# TECHNICAL BULLETIN

Lister Diesels, Inc. • 555 E. 56 Highway • Olathe, Kansas 66061 • (913) 764-3512

Bulletin No. 327

SUBJECT: TS/TL ENGINES

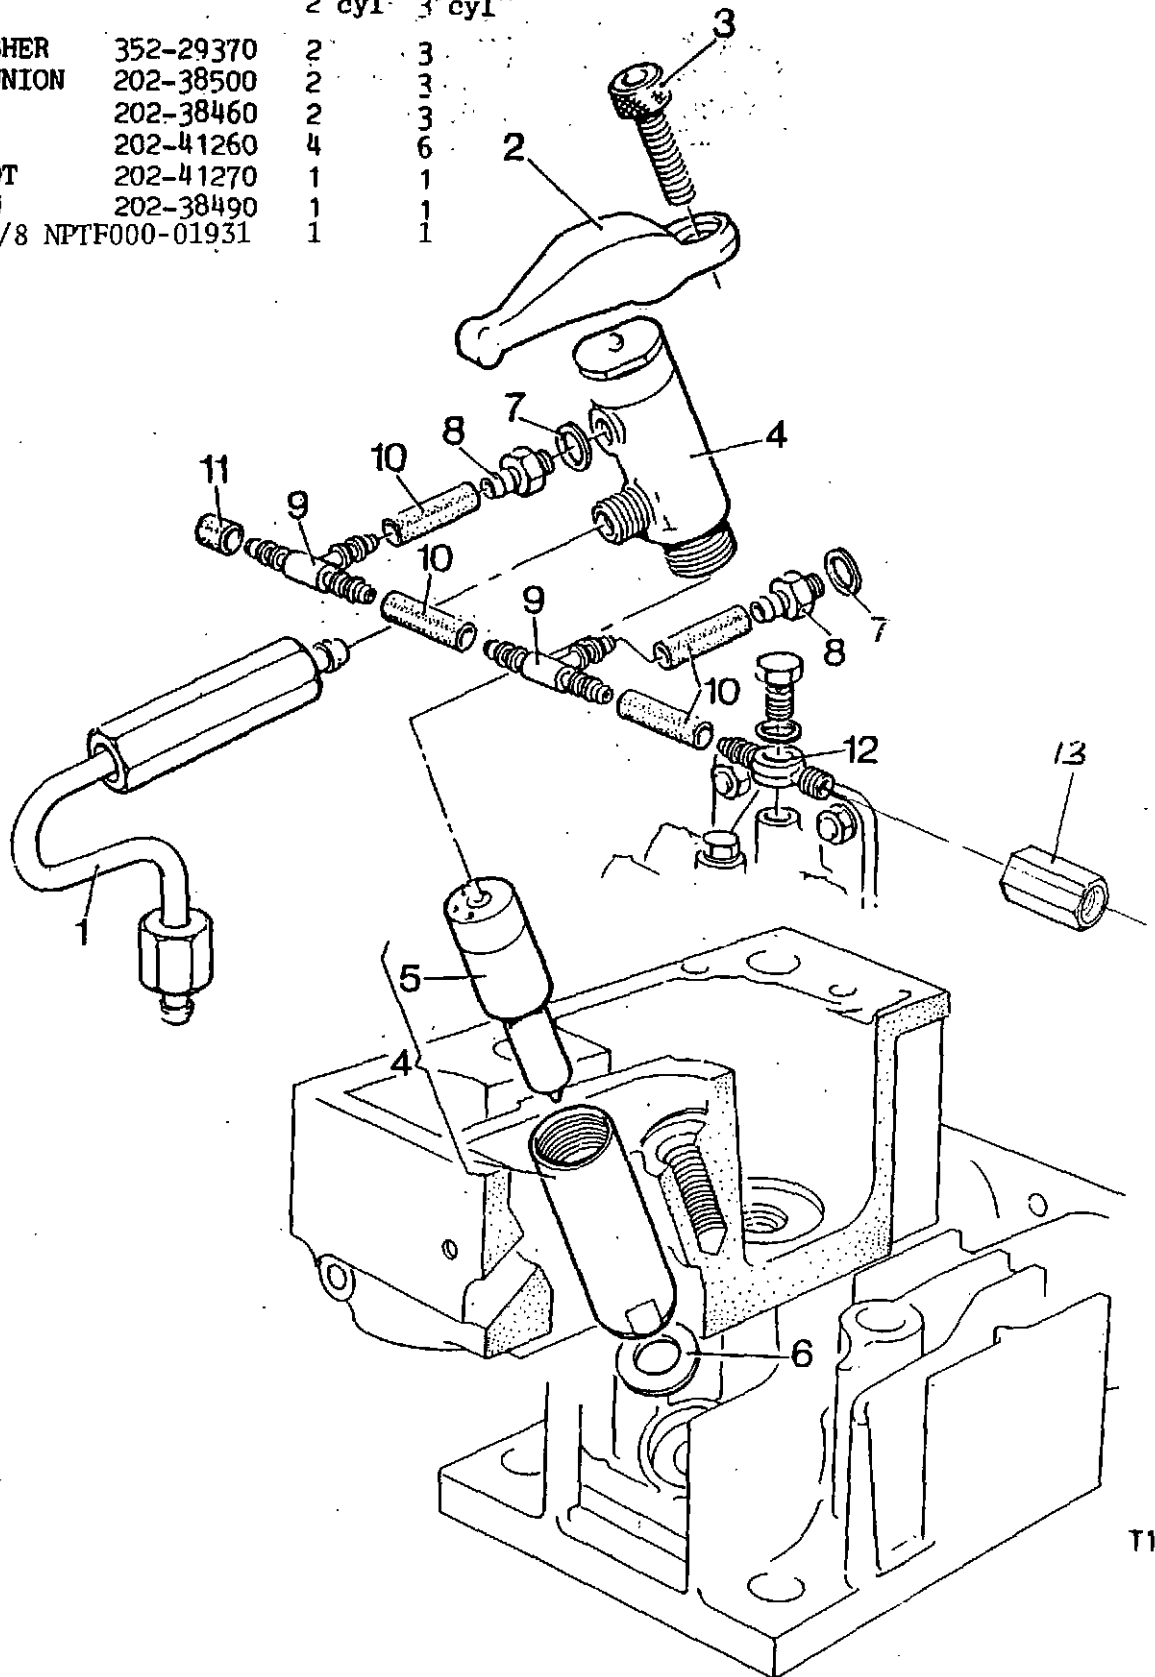
The fuel leak-off system has been redesigned completely and neither the assembly nor the individual components are interchangeable. The attached drawing (T17B), which will be included in the next issue of the TS/TL Parts List 027-08061, shows the new arrangement.

The cylinder head has also been modified to include a D shaped slot for the location of item 10 on the above drawing. Spare cylinder head assemblies 570-30192 will be supplied complete with a blanking grommet 202-41320 to be used when the head is fitted to an engine with the old style leak-off system.

The leak-off connection to the top of the fuel filter is now as shown on the attached drawing item 12. The user is now provided with an 1/8 inch BSP male connection for the return line to his fuel tank.

L.D.I. have introduced a coupling Part No. 000-01931 (shown as item 13 on the attached drawing) to adapt the 1/8 inch BSP male thread to 1/8 inch NPT female. This adaptor is being supplied with all engines having a fuel lift pump.

NEW PLASTIC FAN

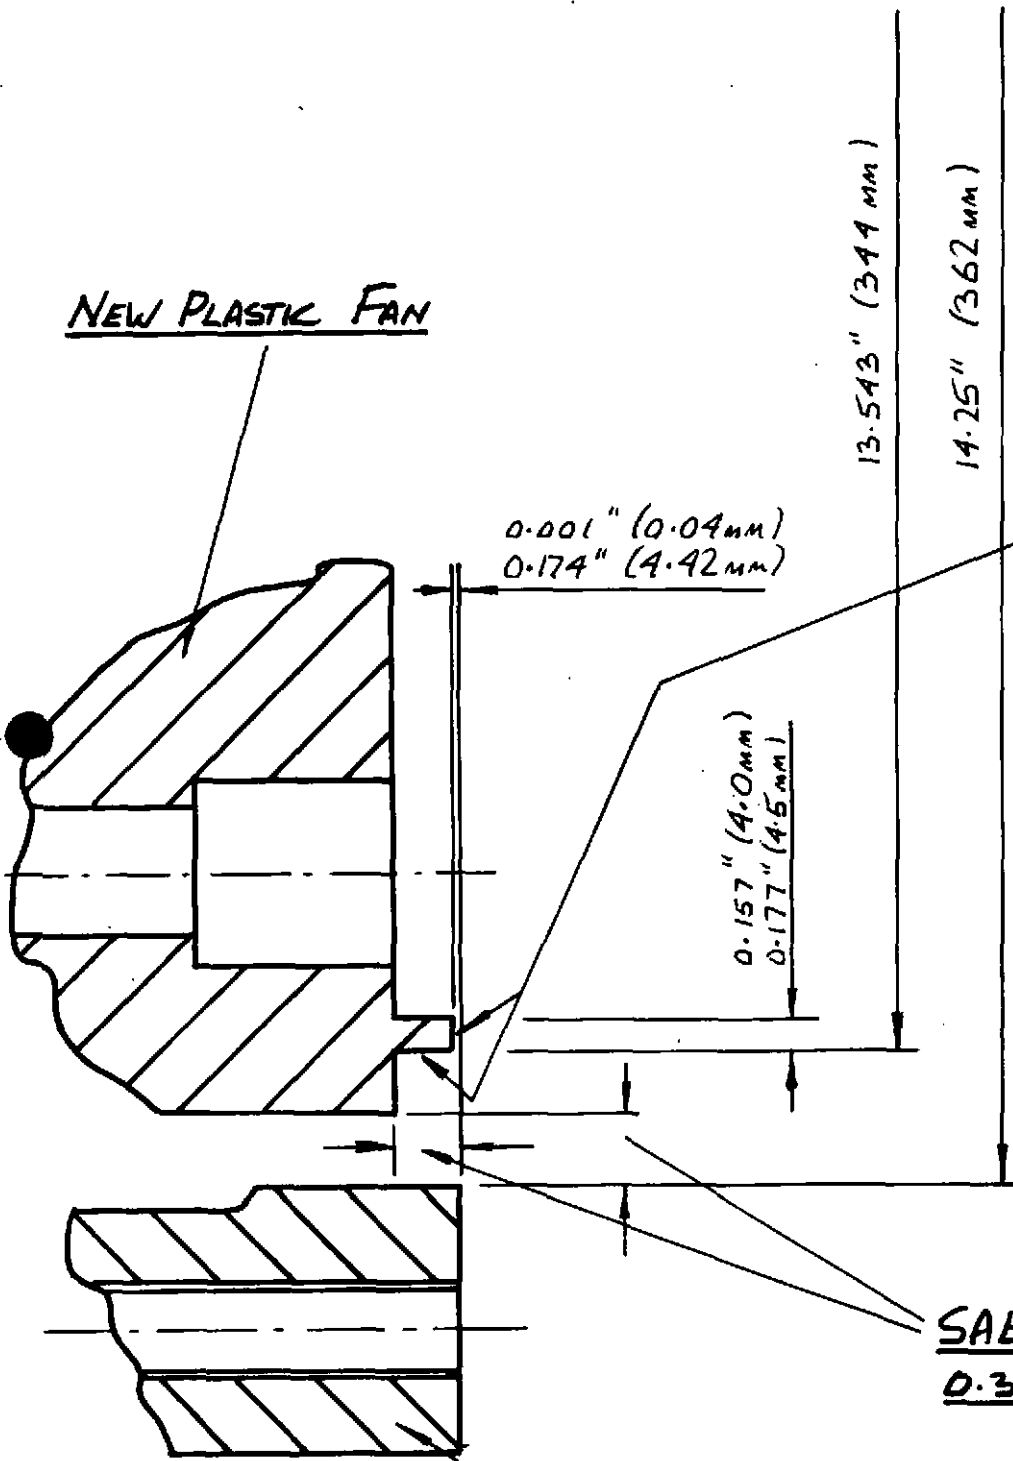
Flywheels have been modified to accept the new fans and neither part is interchangeable with the original ones. Also new cap screws are required.

**IMPORTANT:** The new fan has a stiffening rib which may be a possible foul point against the customers adaptor, see sketch on Sheet 2.

All LDI adaptors have been modified to clear this rib but customers using their own or proprietary adaptors will need to check this point.

POSSIBLE FOUL POINT  
OF CUSTOMERS ADAPTOR  
ON FAN STIFFENING RIB

SAE MINIMUM  
0.31" (7.8mm)
